Access Compliance Report

Public Rights-of-Way

(Curb Ramps)

| Intersection ID: 53281 | Main Street: BENFIELD_RD | Cross Street: I-485_RA | Location: SW |

| ADA ID: CF3F95E2A4DD | Ramp Type: Perp | Initial Pass/Fail: Pass | Overall Compliance: No |

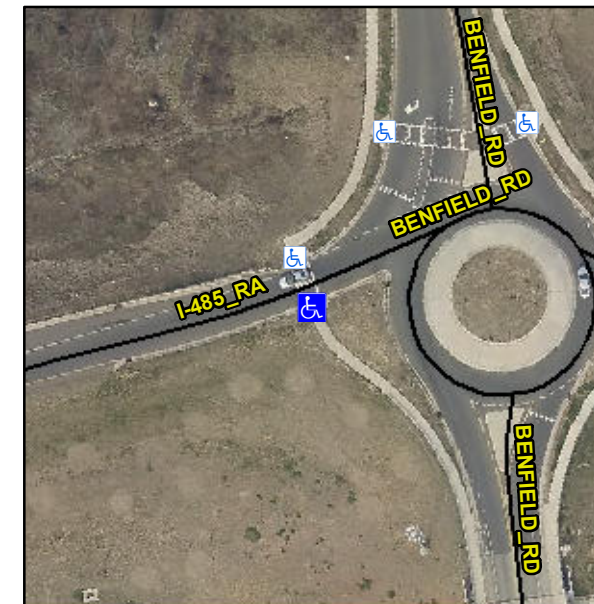
Remove & Replace Landing. Gutter Ponding Observed.

R304.2.2-Perp, R304.3.2-Para, R302.7

| Compliance | Description | Data | Compliance | Description | Data |
|------------|-----------------------|--------|------------|-----------------------------|------|
| No | Landing Slope (%) | 4.4 | Yes | DWS Length (in) | 24.0 |
| No | Gutter Ponding? | Yes | Yes | Gutter Slope (%) | 1.3 |
